April 2, 2007

Project No.: 013-6054

RE: RI/FS WORK PLAN ADDENDUM #2
ADDITIONAL GROUNDWATER TRANSECTS
LIGHTMAN DRUM COMPANY SITE, WINSLOW TOWNSHIP, NJ

FIGURE 1

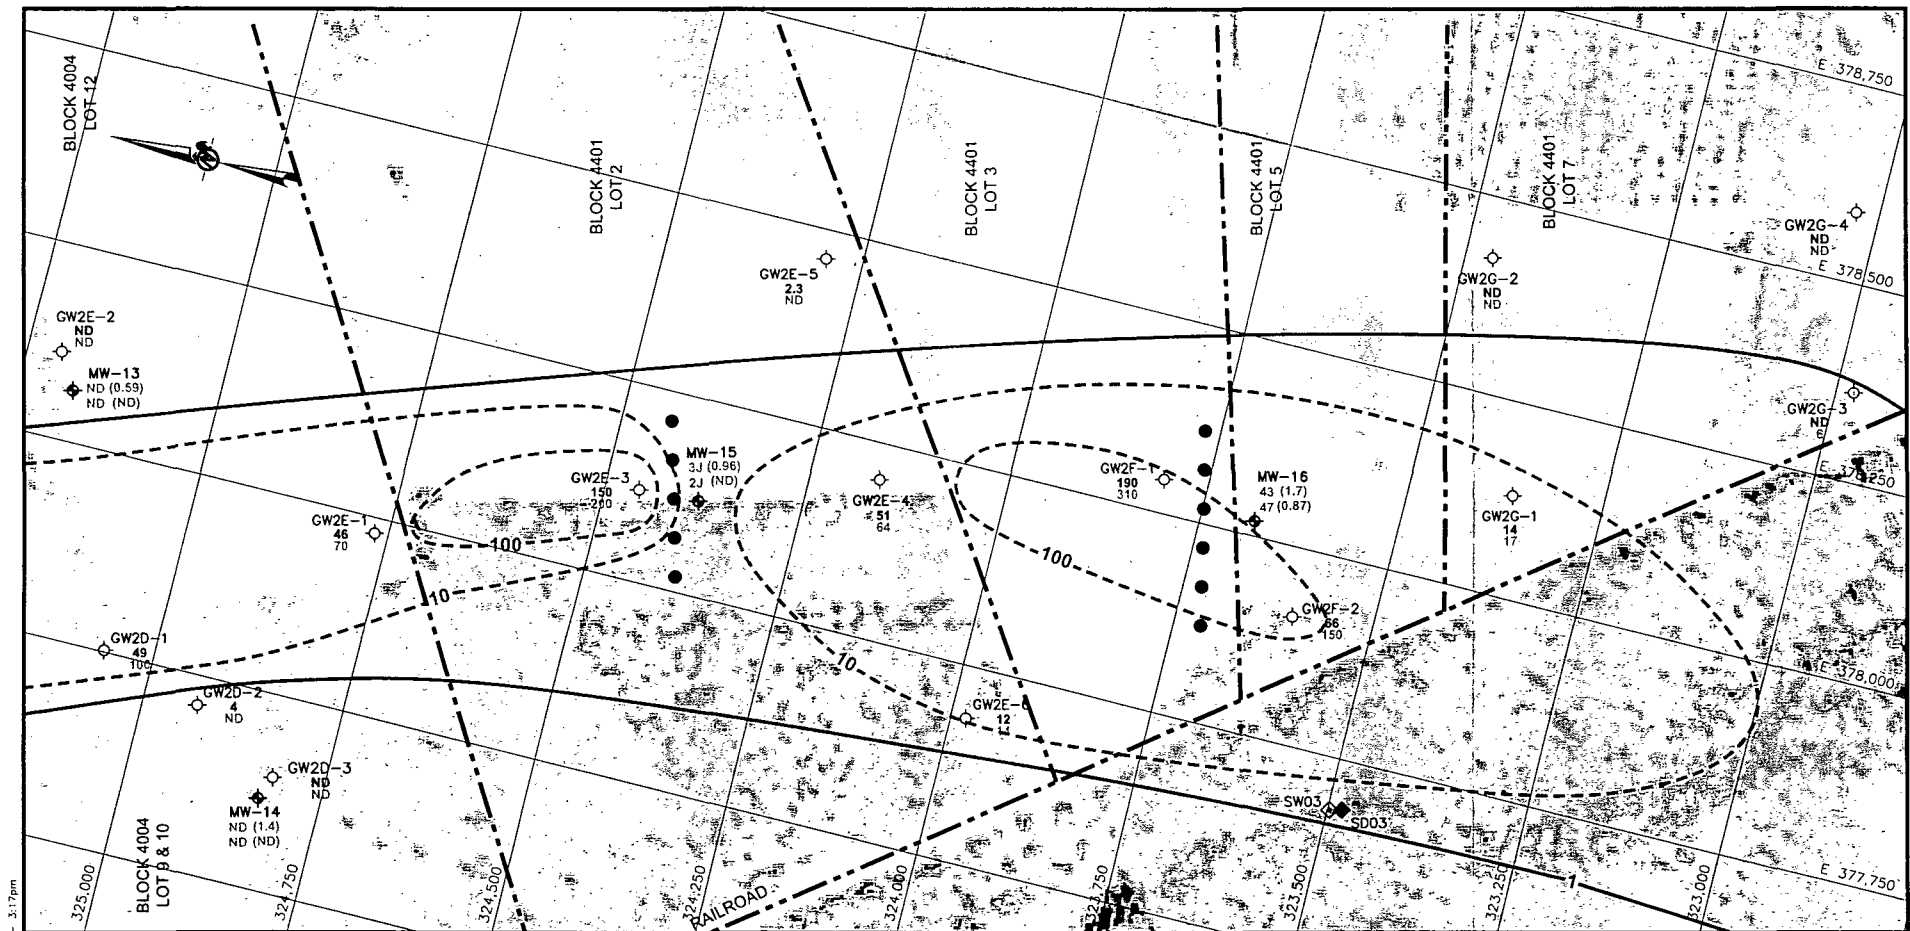
On behalf of the Lightman Yard PRP Group (Group), Golder Associates Inc. (Golder) has prepared this Addendum #2 to the Remedial Investigation/Feasibility Study (RI/FS) Work Plan (Golder, 2002) for the Lightman Drum Company Site (Site) located in Winslow Township, New Jersey. This Addendum is submitted to address additional hydrogeologic investigations downgradient of the Site consisting of eleven aquifer profile borings pursuant to the United States Environmental Protection Agency (USEPA) request in their letter dated March 6, 2007. The Site background, investigation objectives and scope of work for the additional investigation are described herein and the locations of the proposed work area shown in Figures 1 and 2.

Based on geoprobe profile borings¹ and two full rounds of monitoring well data (February 2005 and March 2006), groundwater has been impacted with chlorinated volatile organic compounds (cVOCs), principally TCE and PCE, and aromatic (BTEX) compounds. There are two main plumes present, one originating from the former Waste Storage Tanks (eastern plume), and one from the former Unlined Waste Disposal Pit Area in the western part of the Property (western plume). Both plumes are relatively narrow in width horizontally and in thickness, and both gradually plunge in depth from the source areas so that non-impacted groundwater overlies the plumes starting a short distance downgradient of the Property. The eastern PCE/TCE plume extends a distance of approximately 4,500 feet downgradient of the Property, at which point it is approximately 85 feet below ground surface (bgs). The western PCE/TCE plume extends
